BRAZOS VALLEY SOLID WASTE MANAGEMENT AGENCY

Re: Rock Prairie Road Landfill, College Station, Brazos County, Texas
Municipal Solid Waste (MSW) Permit No. 1444-C
Permit Modification - Landfill Gas Remediation Plan

Proposal for a Trench Collector, Installed to Control
Methane Migration
Rock Prairie Road Landfill
MSW Permit No. 1444C

FIGURE 1

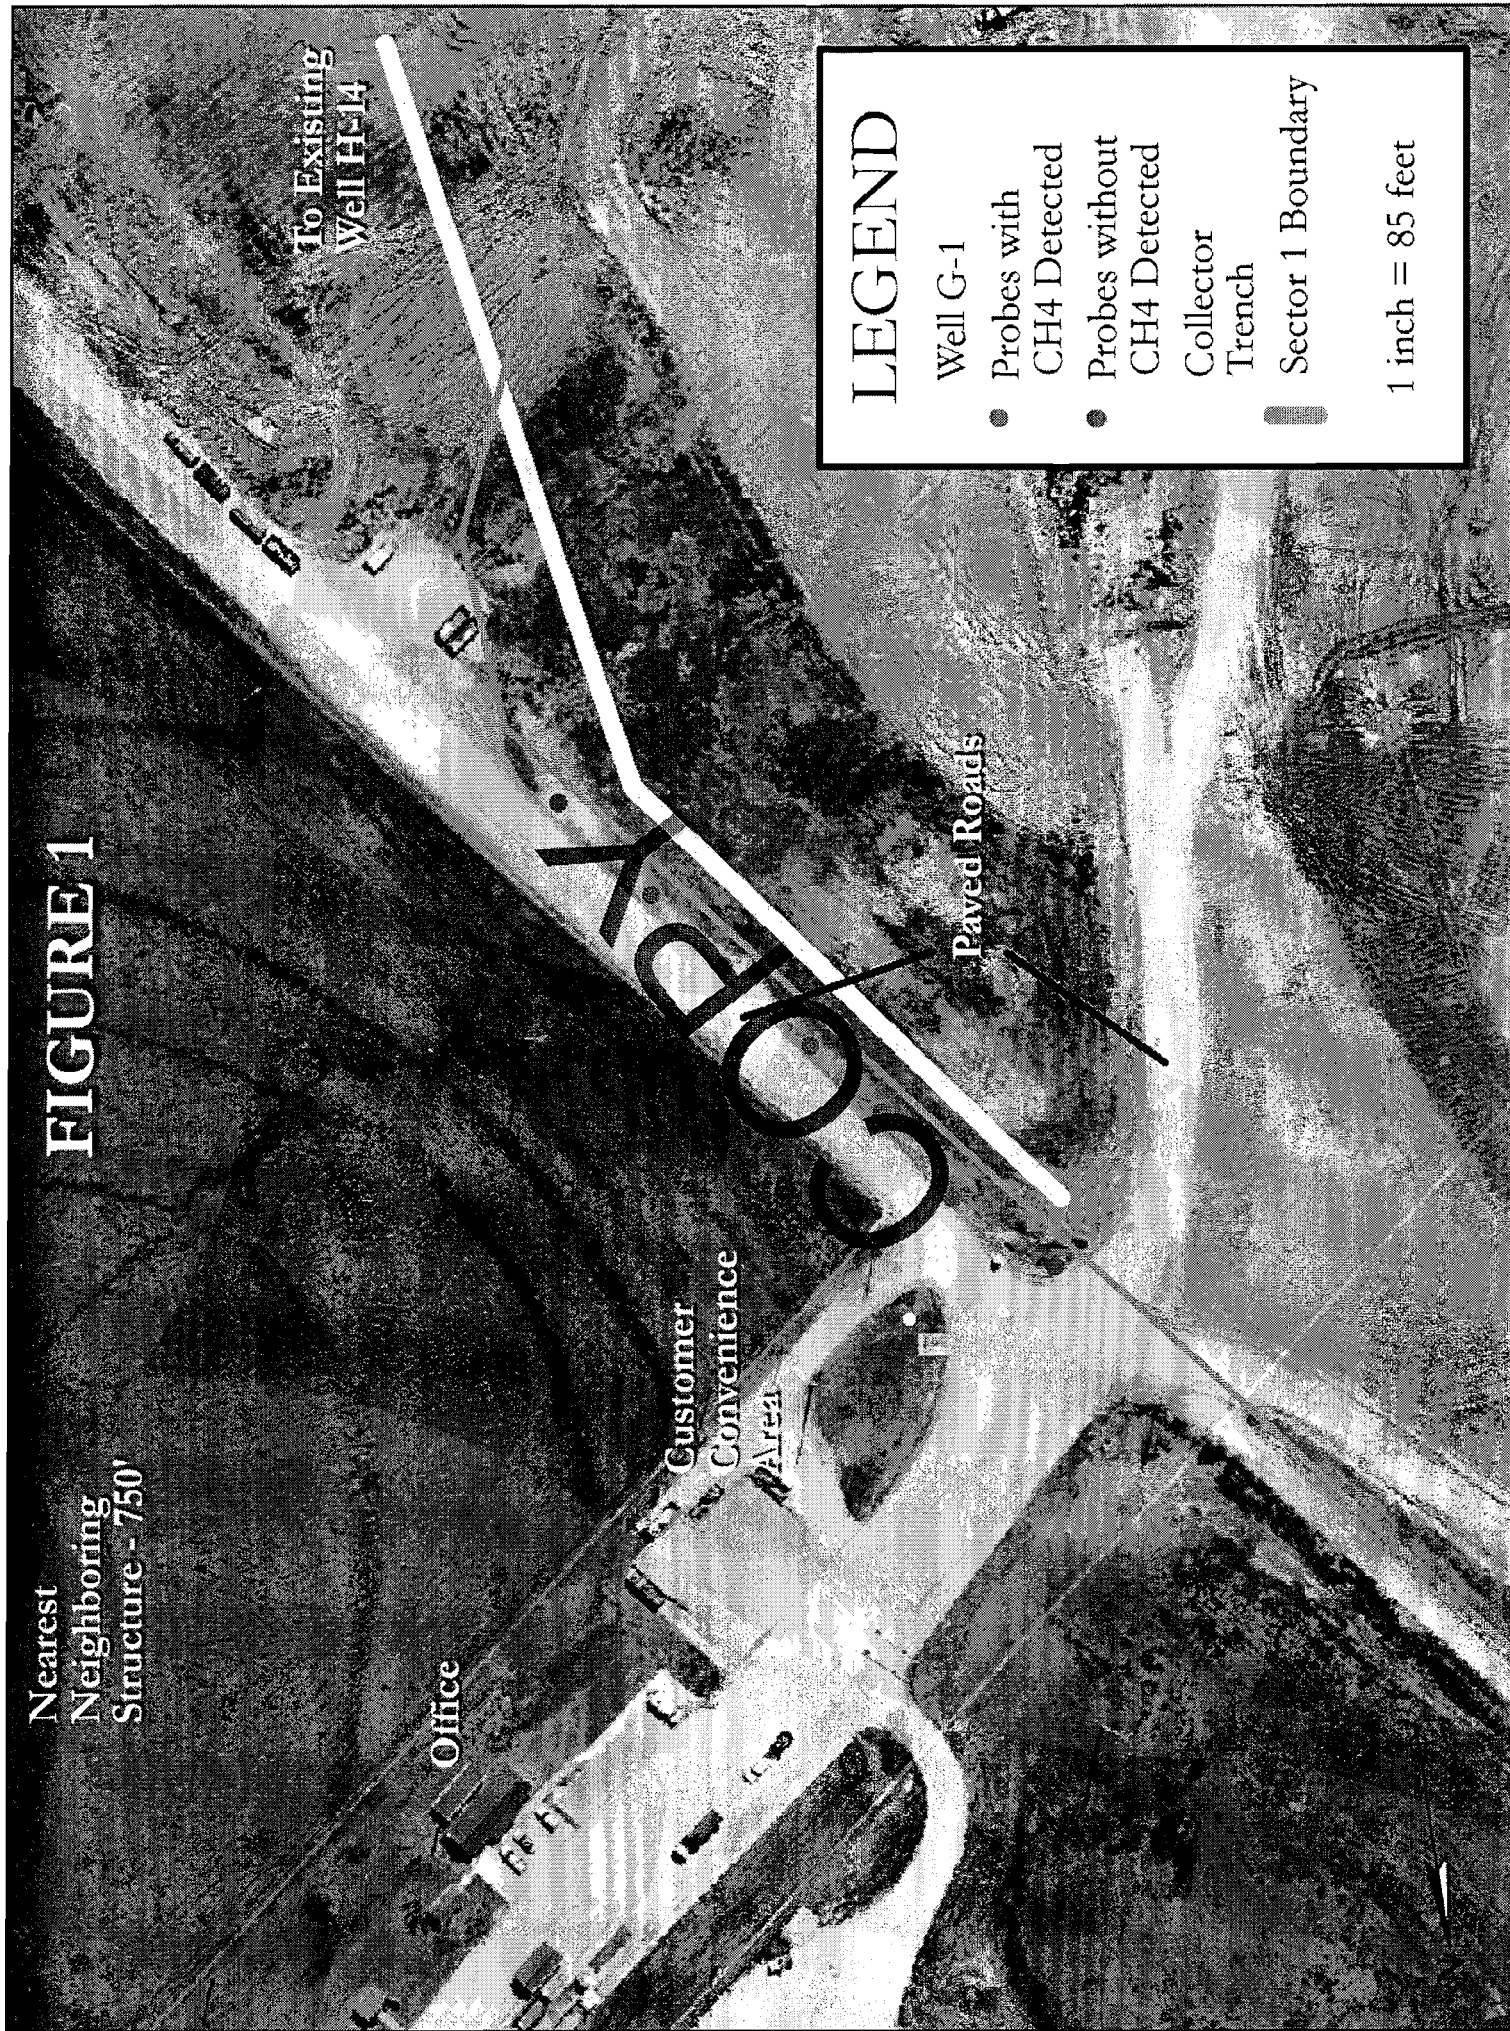
On June 30, 2006, methane was detected at the BVSWM Rock Prairie Road Landfill in gas monitoring probe G-1. The concentration found at that time was 13% methane by volume. Site personnel attempted several bar-hole probes to detect the gas between the monitor well and the landfill in order to track the plume. No methane could be found in any bar-hole probes at a depth of two feet. A nine inch auger was then used to drill five foot test holes along the outside of the anchor trench and surrounding the gas monitoring well. No methane has been detected in any test holes around the well. Methane concentrations of 30-40% are present in test holes along roughly 150 feet of the anchor trench. Contained in this proposal is a map of the relevant area with locations of the test holes (Figure 1) and chart showing test hole readings found at these locations (Figure 2).

Figure 3

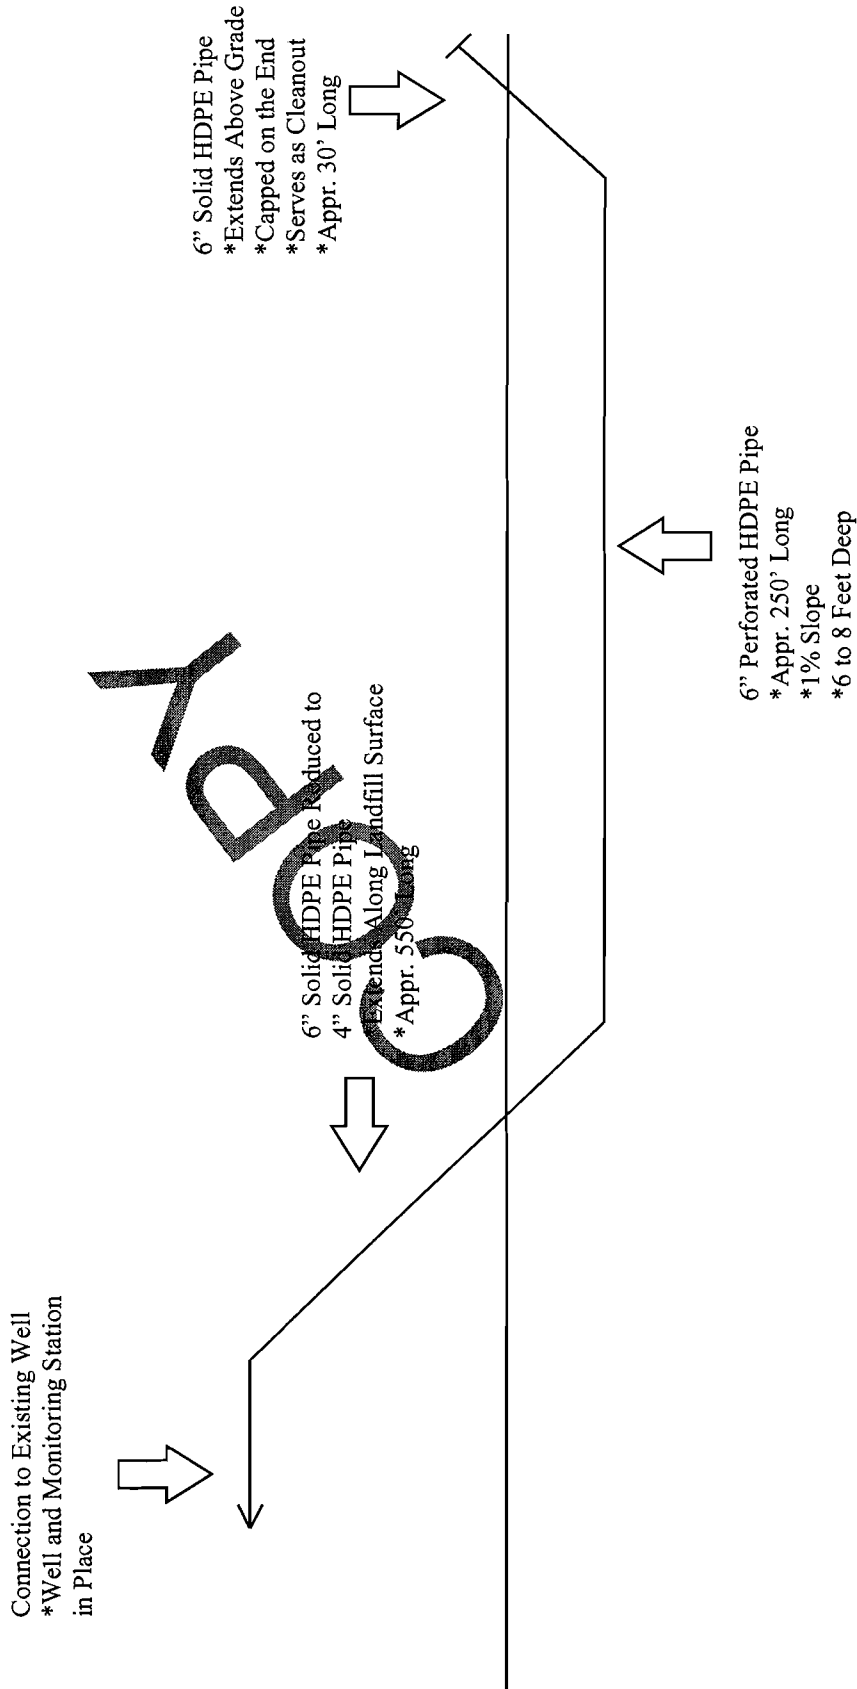
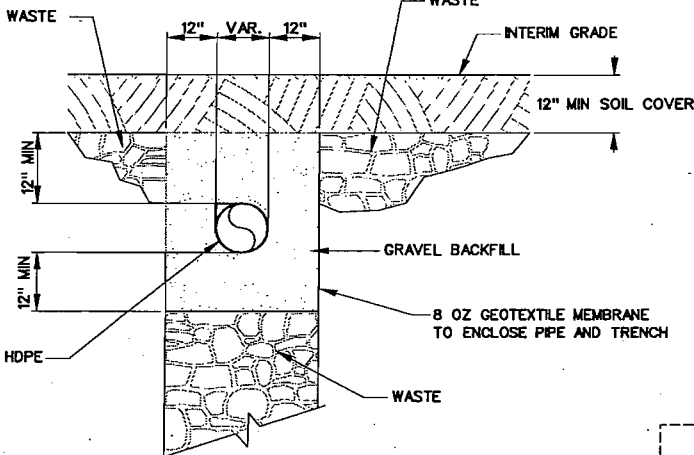
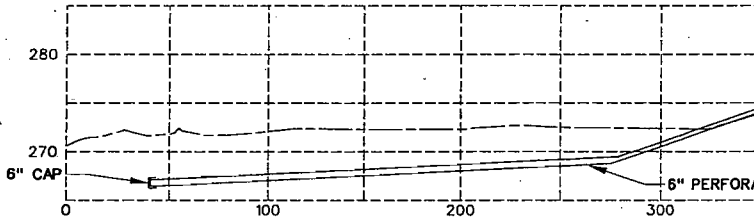
Refer to Figure 3 for a schematic of the proposed trench collector. The trench collector, a 6" perforated HDPE pipe, will be placed in an eight foot trench excavated within the waste and will be positioned as close as possible to the liner system to create ultimate influence of the traveling gas but without disturbing the integrity of the liner. The perforated section of pipe will be packed in 2' rock and backfilled with compacted trash/soil to final. With the length of area experiencing methane migration being approximately 150', the trench and pipe will extend 50' on both ends making the total length of active vent pipe to 250' to ensure successful collection of landfill gas. The depth of the trench will vary due to a 1% slope down to the north, away from the vertical well installation. The trench pipe will be connected to a 4" solid HDPE pipe with an eccentric reducer that will extend approximately 550' on the landfill surface to tie into existing vertical gas well H-14. The 4" solid pipe will then be connected to existing vertical well H-14, an unutilized well due to poor methane quality produced, so that we may take advantage of the monitoring equipment already in place at the well's monitoring station (temperature port, orifice plate for flow determination, flow control

valve and connections for gas quality readings). At the end opposite the connection, the trench pipe will extend above grade with a solid section of pipe and be capped. In case the pipe becomes watered in, this extension will serve as a cleanout.
